## Starter Drive Material Change – 35 thru 275

Mariner/Mercury 35 thru 275 with the following starter motor part numbers:

11645

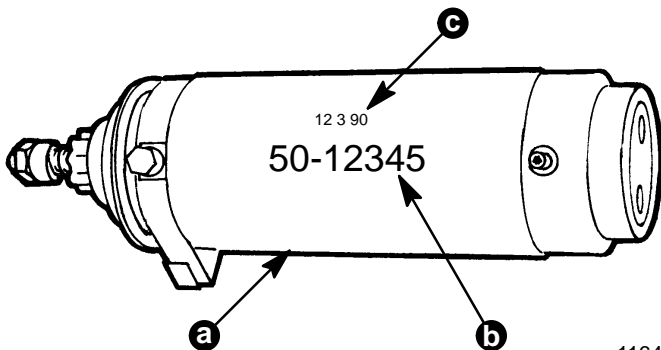
The new drive can be identified by locating the raise mark on the face hex area of the drive backing plate. All starter motors listed will have the new drive gear installed as of Date Code 11-16-90 identified by white numbers on starter motor housing next to part number.

51281

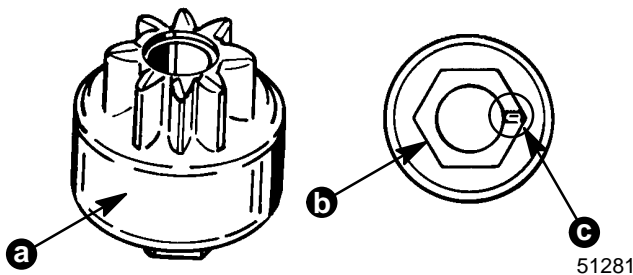
The starter motors listed had a material change on the starter drive backing plates. This improved starter drive will help reduce the possibility of the drive gear sticking down on the drive stop of the armature when the starter motor is energized.
